PLANNING, ZONING, & BUILDING DEPARTMENT
PZ&B Staff Memo: Architectural Commission

SUBJECT: ARC-23-110 (ZON-23-079) 2773 S OCEAN BLVD (COMBO)

MEETING: SEPTEMBER 27, 2023 ARCOM

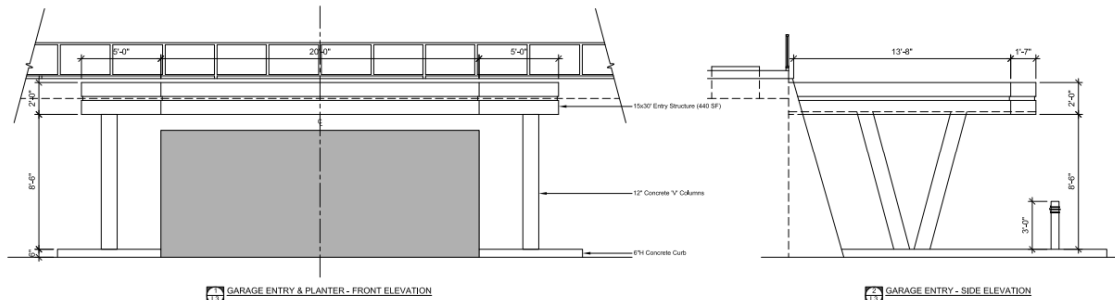
- **SITE PLAN REVIEW:** Sec. 134-1052(4): Site Plan Review for modifications to an existing multi-family site. ***Approved by Town Council.***
- **VARIANCE 1:** Sec. 134-1060(9)(d) For multifamily uses, the maximum lot coverage is 40 percent. to retain an existing nonconforming landscape open space of 21% where 35% is required and 20% is existing. Sec. 134-1064(a)(2) Five-story guidelines. Lot coverage

not more than 22 percent. Canopied entry awning coverings count towards lot coverage, amend calculations. **Approved by Town Council.**
